STAFF REPORT AMENDED 6-12-80
CITY PLANNING COMMISSION

- APPLICATION:
1. Negative Declaration
 2. Amendment of 1965 Lindale-Florin Community Plan for 2+ vacant acres from Shopping-Commercial to Light Density Residential
 3. Rezone 6+ vacant acres from General Commercial, C-2 and Single Family R-1 to Townhouse R-1A
 4. Special Permit to allow 62 condominium units
 5. Tentative Map (P-9004)

LOCATION: Southeast corner of Stockton Boulevard and 48th Avenue

PROPOSAL: The applicant is requesting the necessary entitlements to subdivide an 8+ vacant parcel into one commercial parcel and one parcel to be developed with a 62 unit condominium project to be known as Stonewood.

TENTATIVE MAP
STONEWOOD
 CITY OF SACRAMENTO, CALIF.
 March 1980

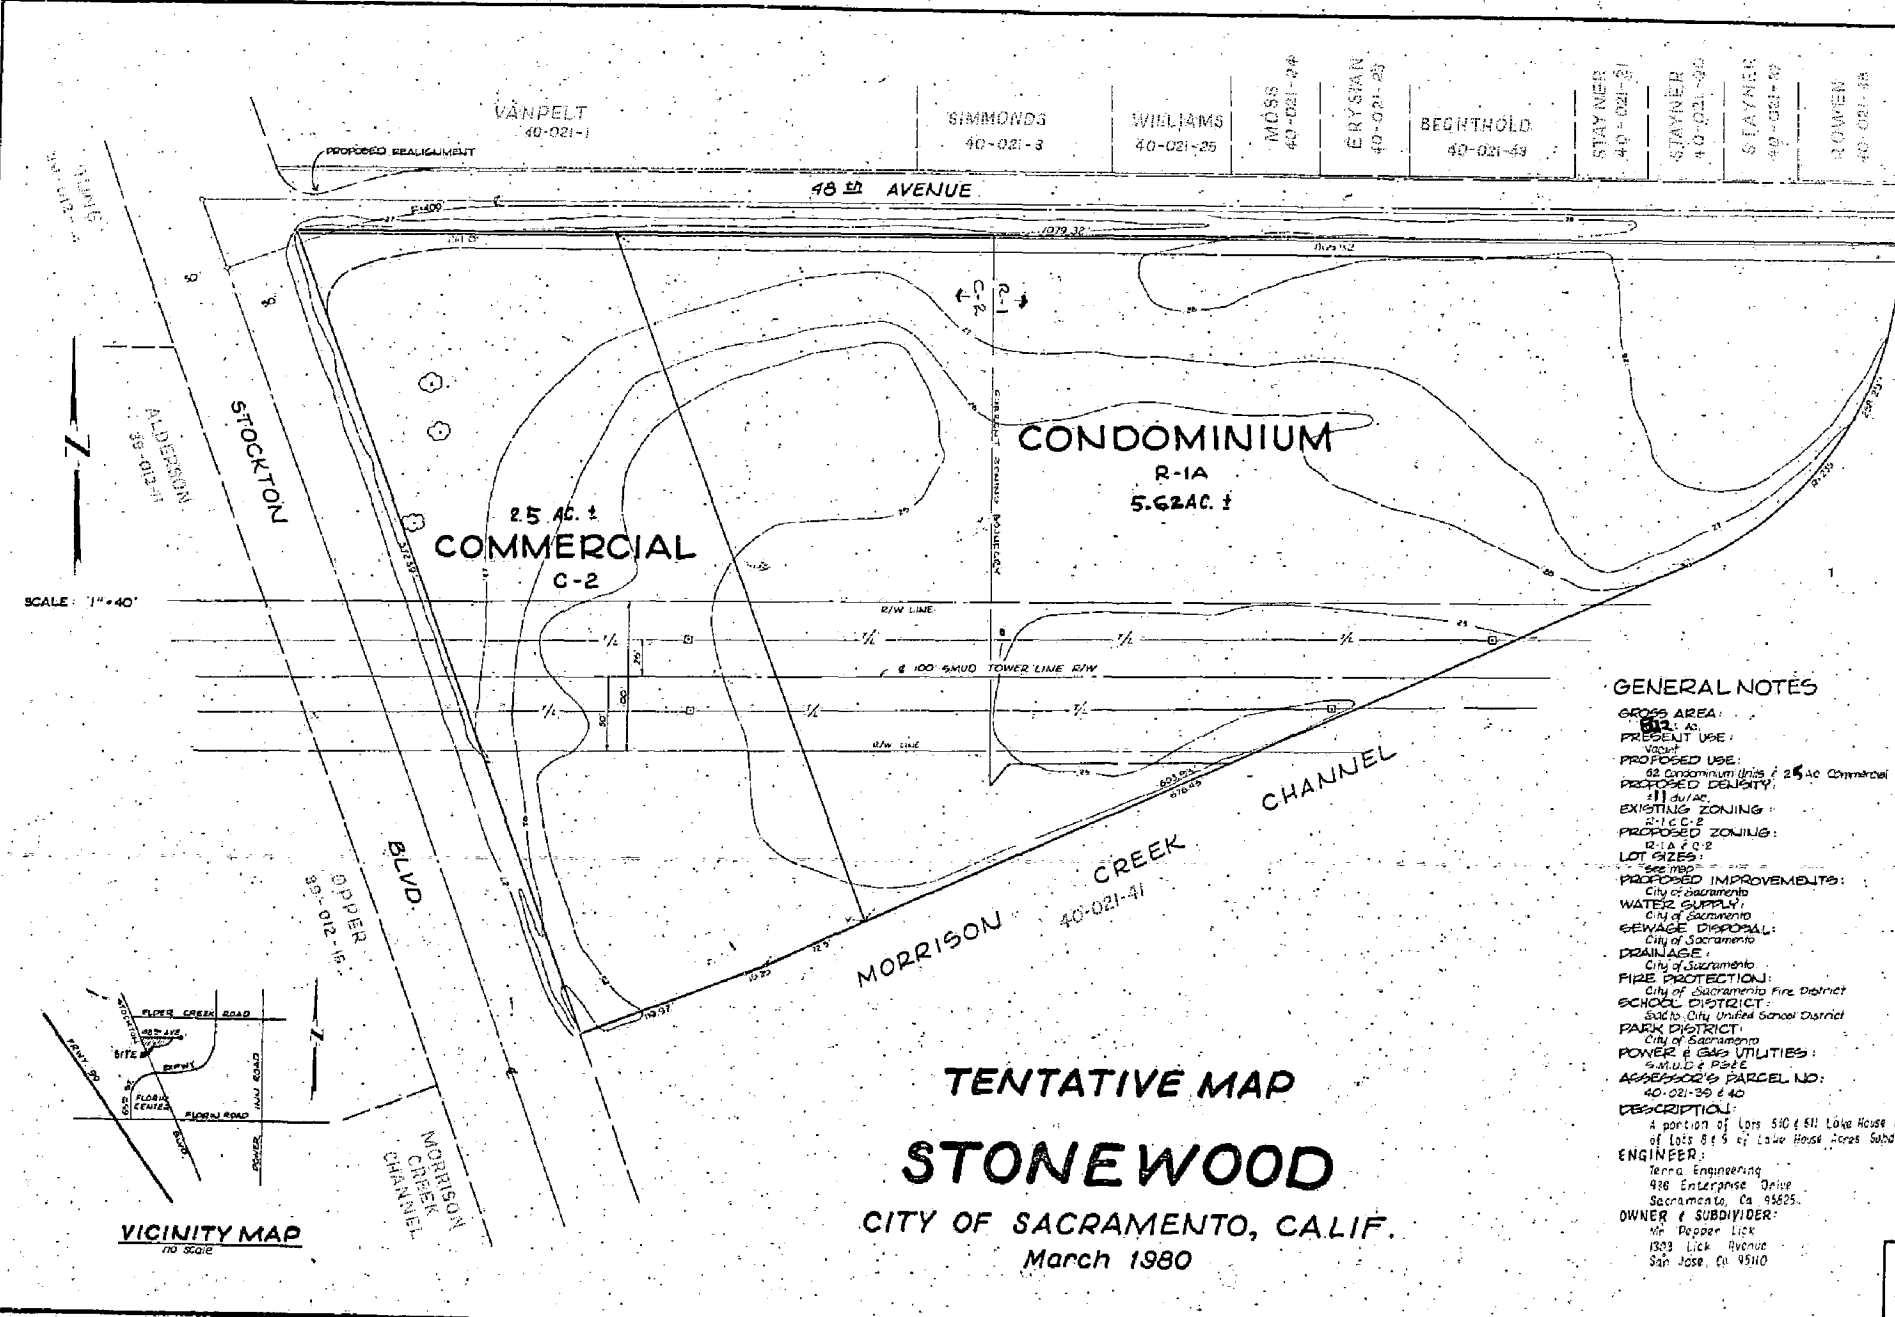
SUBDIVISION REVIEW COMMITTEE RECOMMENDATION: On May 28, 1980 the Sub-division Review Committee, by a vote of six ayes, three absent, recommended approval of the tentative map subject to the following conditions:

- a. The applicant shall provide standard subdivision improvements along Stockton Boulevard and 48th Avenue pursuant to Section 40.811 of the Subdivision Ordinance prior to filing the final map. Applicant shall also provide for a 12-foot lane on the north side of 48th Avenue.
- b. The applicant shall prepare a sewer and drainage study for the review and approval of the City Engineer-must construct oversized and off-site main extension to Morrison Creek prior to filing the final map.
- c. The applicant shall name the streets to the satisfaction of the Planning Director.
- d. Right-of-way study required and possible dedication required along Stockton Boulevard.
- e. Applicant shall dedicate 27-foot half section along 48th Avenue and round corner.
- f. Applicant shall dedicate cul-de-sac bulb (south side) on 48th Avenue.

4. Approval of the Special Permit request subject to conditions which follow.
5. Approval of the Tentative Map subject to the following conditions:
 - a. The applicant shall provide standard subdivision improvements along Stockton Boulevard and 48th Avenue pursuant to Sec. 40.811 of the Subdivision Ordinance prior to filing the final map. Applicant shall also provide for a 12-foot lane on the north side of 48th Avenue;

- b. The applicant shall prepare a sewer and drainage study for the review and approval of the City Engineer prior to filing the final map and must construct oversized and off-site main to Morrison Creek;

- c. The applicant shall name the streets to the satisfaction of the Planning Director;
 - d. Right-of-way study required and possible dedication required along Stockton Boulevard;

- e. Applicant shall dedicate 27-foot half section along 48th Avenue and round corner;
 - f. Applicant shall dedicate cul-de-sac bulb (south side) on 48th Avenue;

PROPOSED EXTERIOR - STOCKTON BLVD.
PEPPER SNYDER

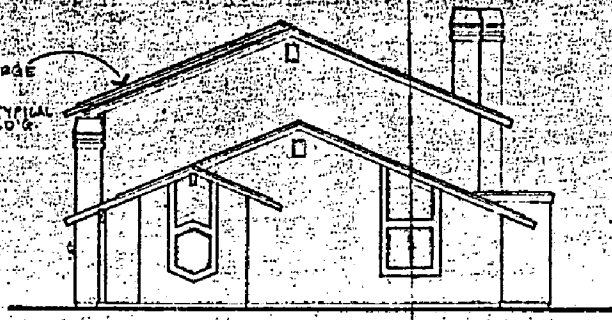
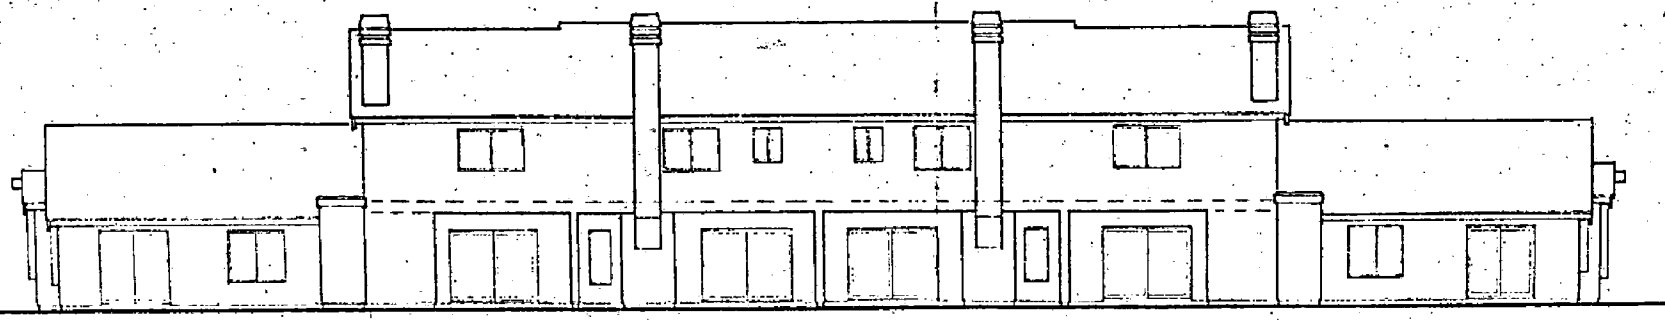
2. The applicant's plans indicate a mixture of one and two-story units clustered in groups of three to six units. Staff also notes that detached garages are provided throughout the site. The exterior building materials will be a mixture of roof sown plywood and stucco. In addition, the applicant indicates wood shakes will be utilized. Staff does not have any objection with the proposed structure.

- a. The applicant shall submit a detailed landscape and irrigation plan for the review and approval of the Planning Director prior to the issuance of building permits. These plans shall include the design elements as discussed in Item 4 of Staff Evaluation.
- b. The applicant shall submit a revised site plan which includes a common swimming pool for the use of the homeowners. This pool shall be constructed and in operation prior to the issuance of occupancy permits;
- c. The applicant shall use wood shingles or shakes for the roofing material of the units and utilize a mixture of wood and stucco for the side elevations, as illustrated by the elevations.

SCHMATIC SITE PLAN

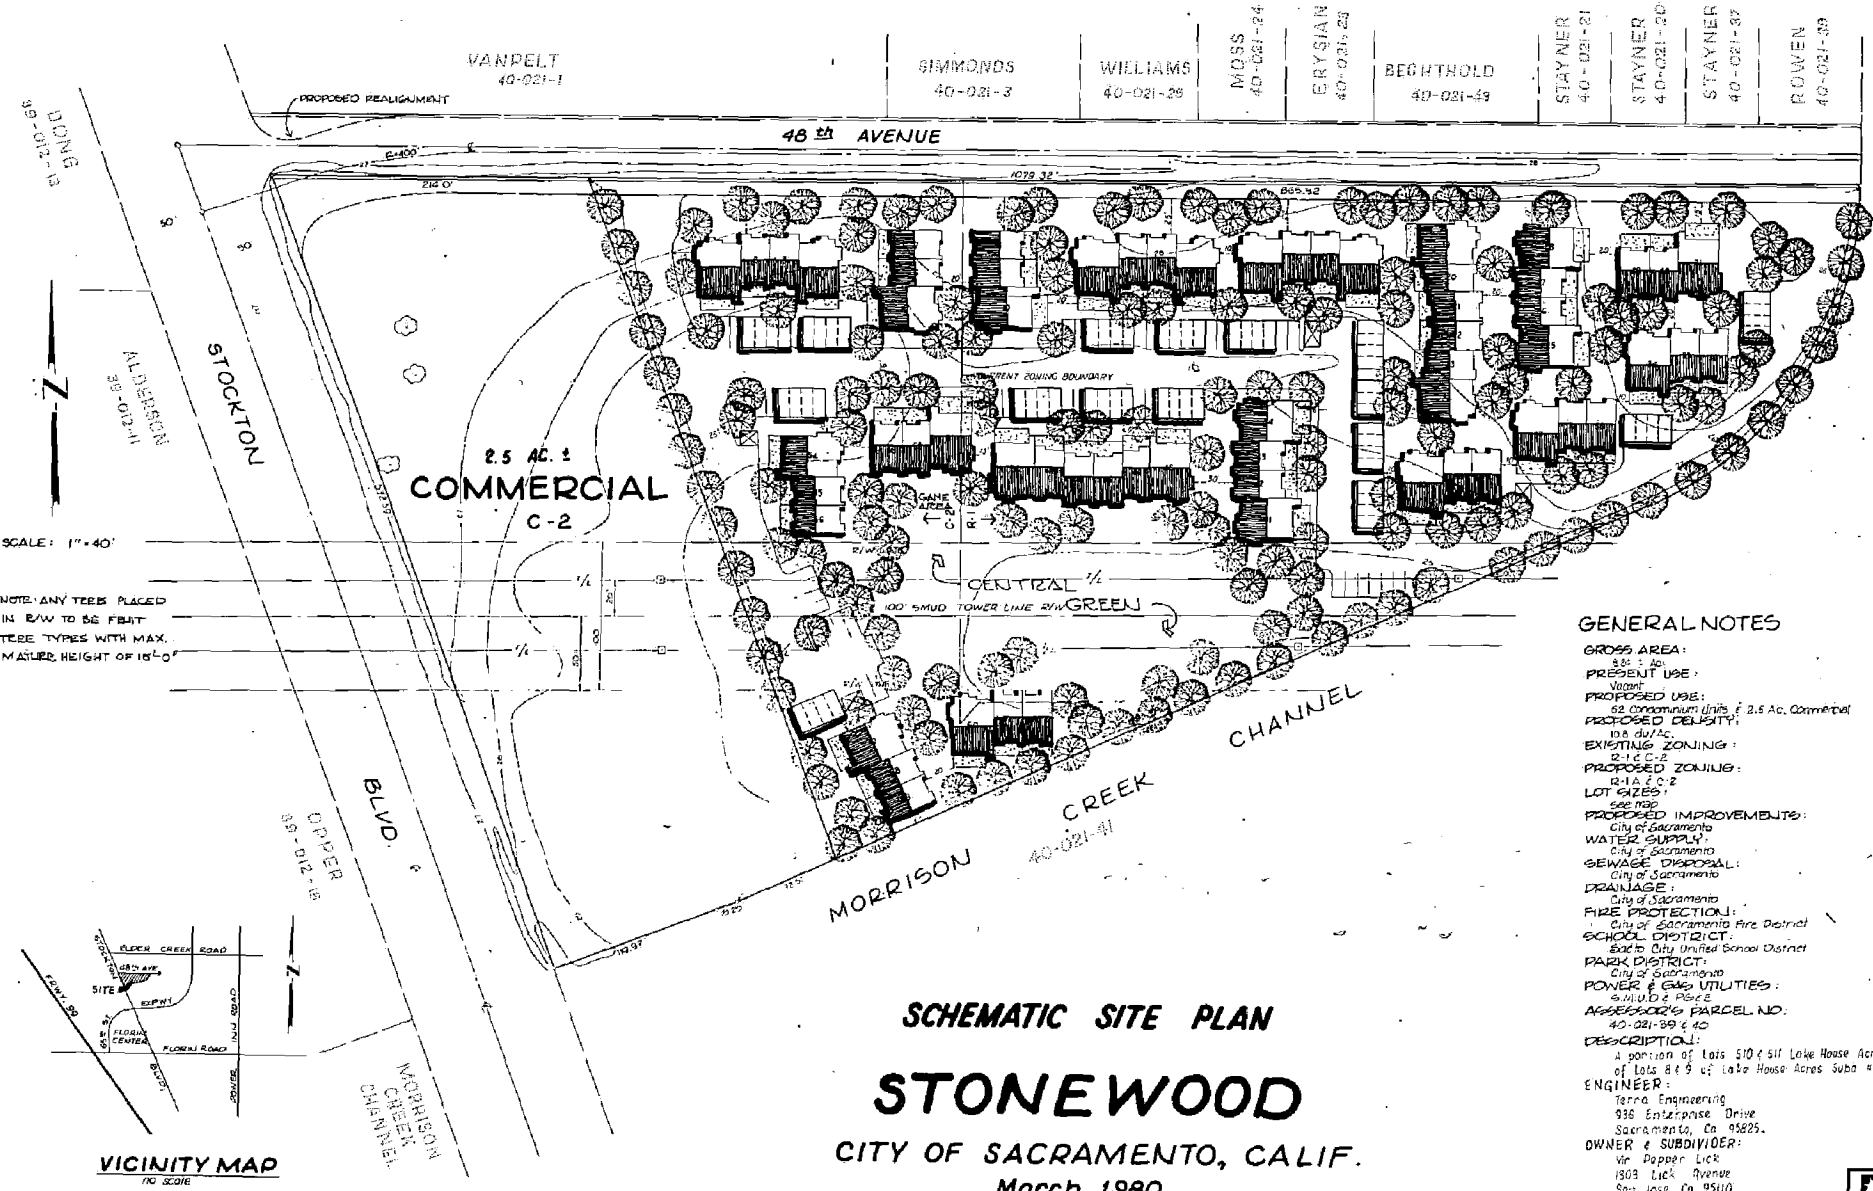
3. Staff notes that the site plan indicates a variable setback ranging from 15 feet to 27 feet along 48th Avenue. The site plan also provides for a minimum 10-foot setback from all the other property lines. Staff requests that the setback along 48th Avenue be intensely landscaped and bermed to a height of four feet, measured from the sidewalk or building pad, whichever is higher. Staff also requests that the applicant provide for a solid six-foot high masonry wall adjacent to the commercially zoned parcel.

5. The applicant's proposal indicates a central recreational area located primarily under the 100-foot powerline easement. Condominium projects usually include more in the way of amenities than just common open space. Such amenities include pools, spas, recreational rooms and tennis courts. In keeping with the concept of a planned development, staff suggests that a swimming pool be provided.
6. The site plan does not show the location of pedestrian paths. Staff is concerned with the units that face 48th Avenue. The orientation of these units encourages the use of on-street parking. Staff suggests that pedestrian walkways and berming be designed to encourage the use of off-street parking spaces.

- d. Pedestrian walkways shall be shown on the final building plans. The units that are facing 48th Avenue shall include walkways that encourage the use of off-street parking.
